Rezoning Transportation Analysis

Petition Number: 2016-112

General Location Identifier: 07111401, 07111402, 07111403...

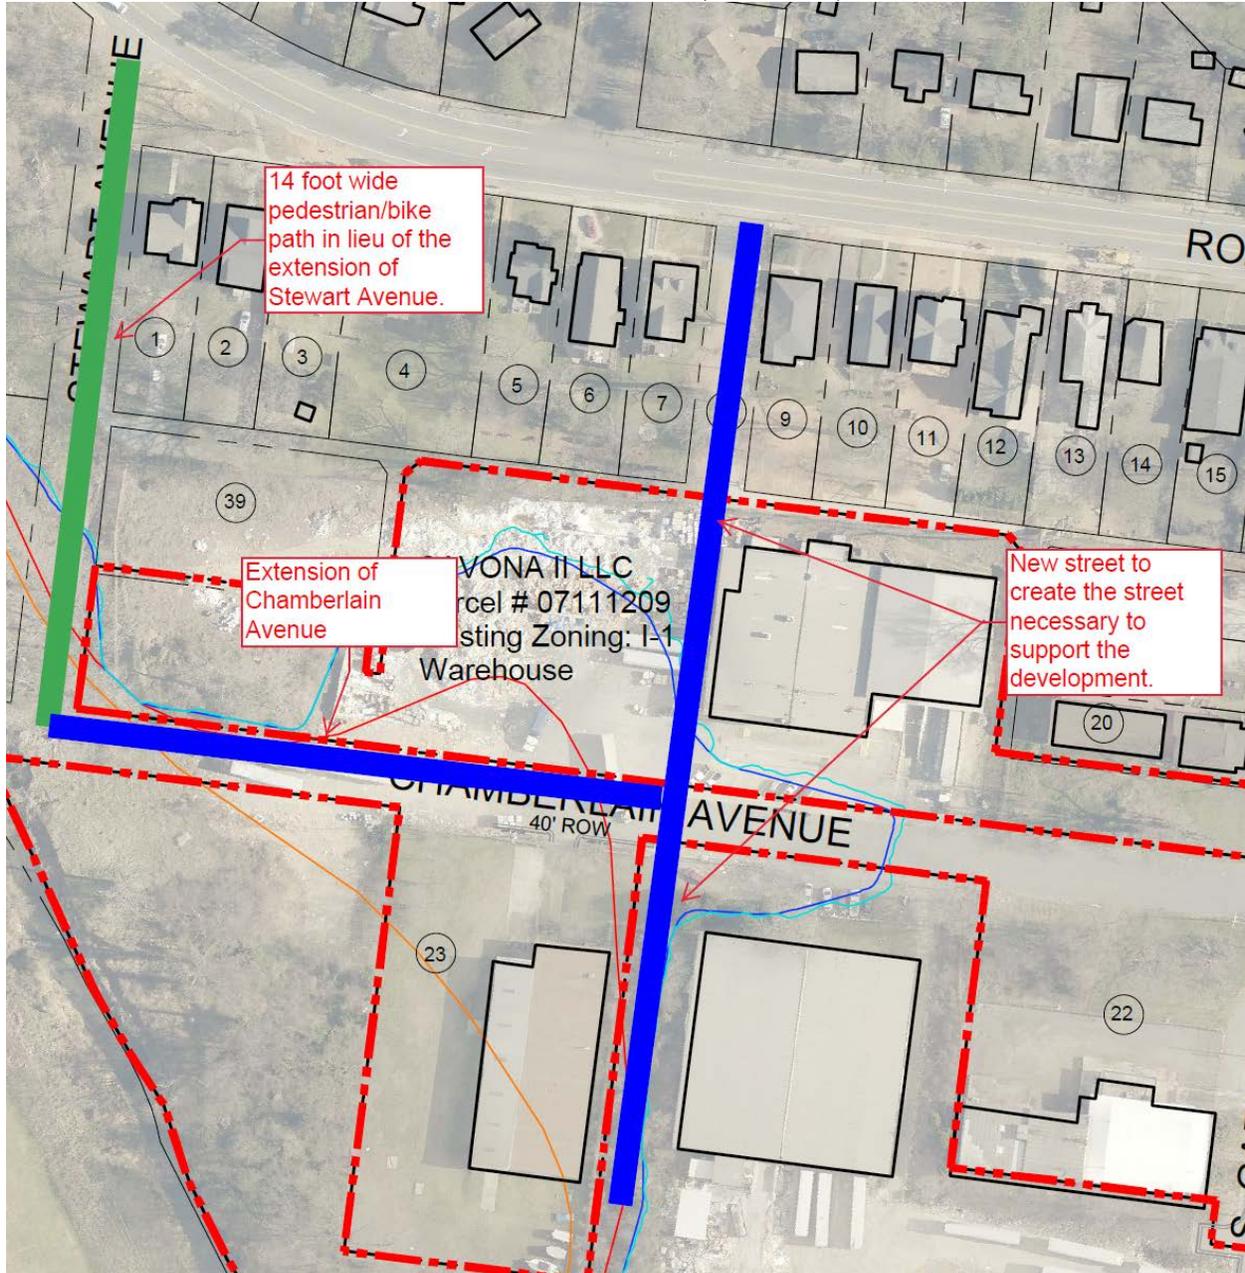
4. ~~CDOT does not agree with MUDD-O Optional Provision "d". Doors for proposed buildings cannot encroach into the sidewalk or pedestrian path.~~
5. The petitioner should revise the site plan to show the extension of Chamberlain Avenue to Stewart Avenue.
 - a. Show the extension of Chamberlain Avenue to the proposed non-vehicular connection

Or

- b. Update site plan and conditional notes showing the proposed non-vehicular connection from Stewart Avenue connecting to where Chamberlain Avenue terminates.
